# Bendix SR-5 Trailer Spring Brake Relay Valve Recall

July 2016

Sectional view of check valve assembly in seated position

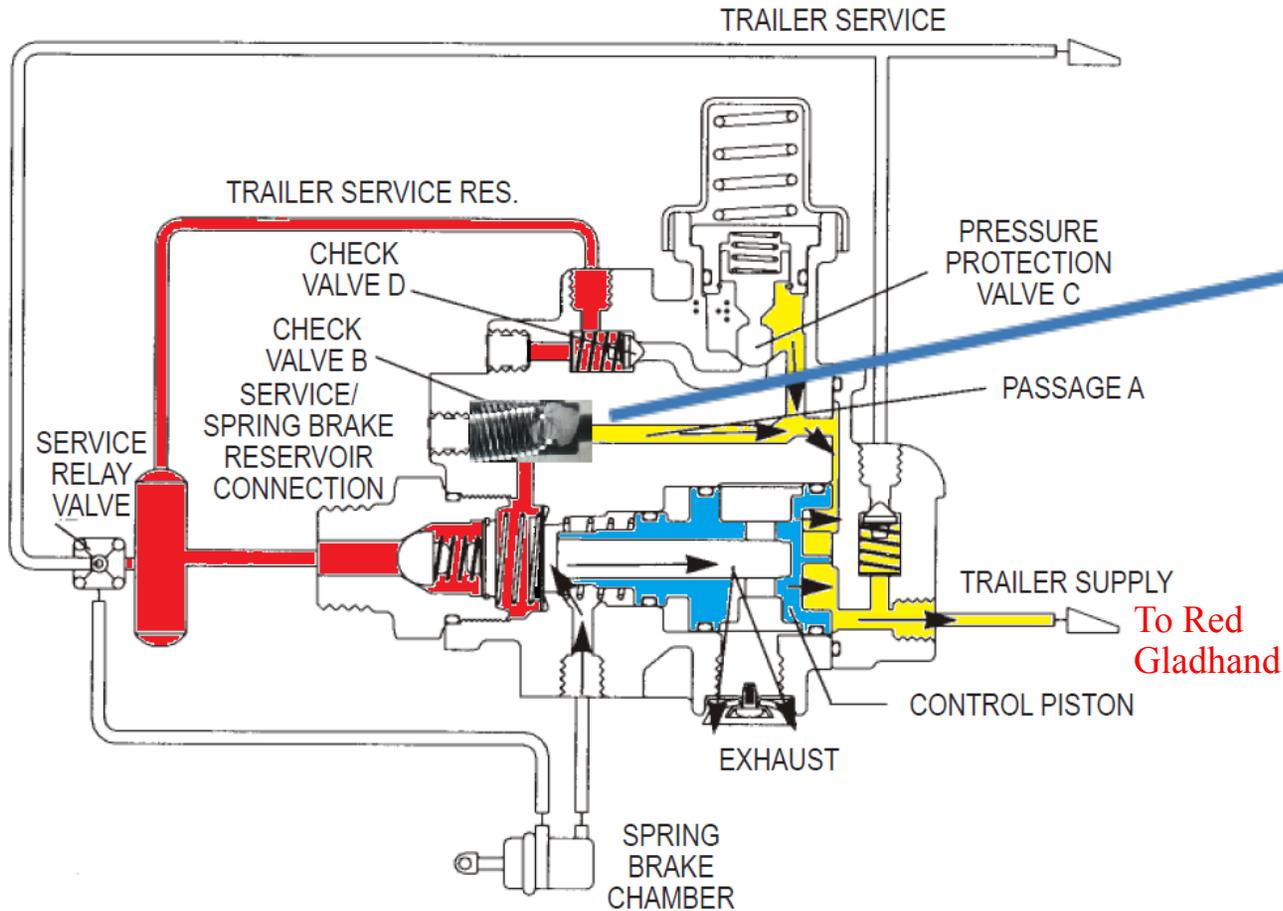
## Missing Radius on Aluminum valve Body

When combined with certain field conditions – causes misalignment of internal Check Valve

**Caught on Sharp Edge**

**Missing Radius on Valve Body**

**Check Valve seat**  
(Radius Present / Radius Not Present)

**If Valve becomes Misaligned, Leakage can be Large enough to cause 'Slow to Park'**

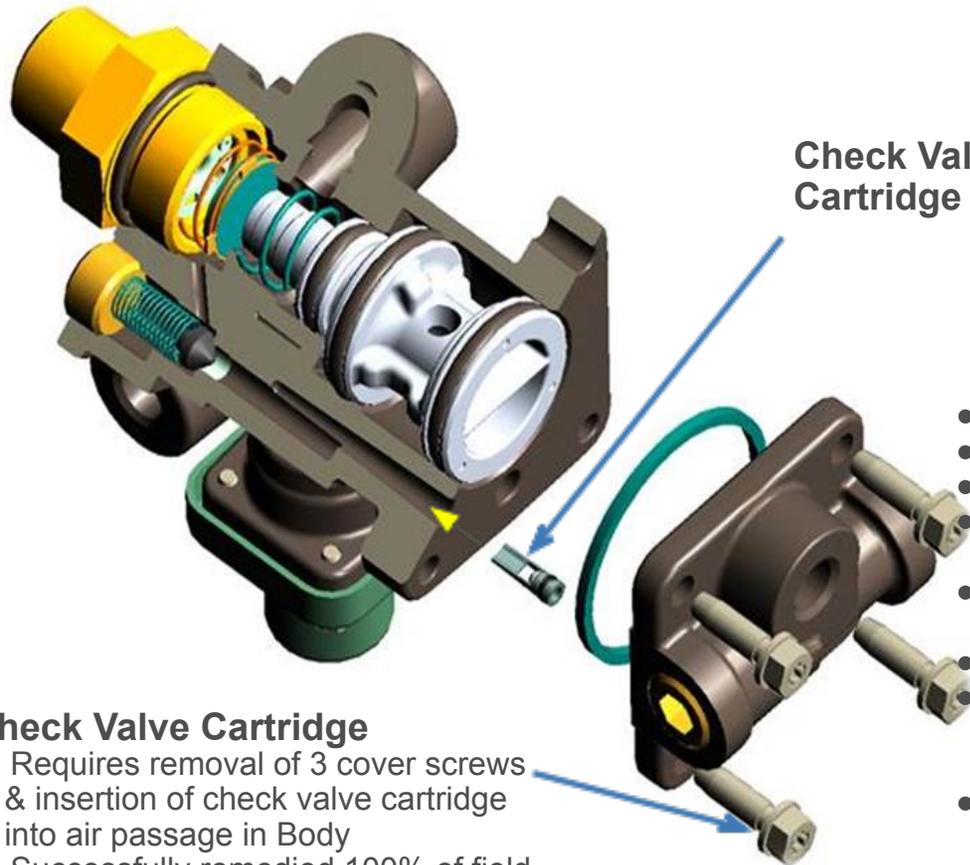
If Leakage is present (& large enough), the leaking air provides enough back pressure on the main control piston (**BLUE**) to prevent normal movement.

If the main piston does not move, immediate exhaust (<3 seconds) cannot happen.

This is how the leakage from the check valve is causing the 'slow to park' condition.

Once leakage fully exhausts tank pressure, the backpressure drops, the main piston moves & the trailer parks.

Missing Radius (combined with other conditions) can cause leakage – preventing immediate parking
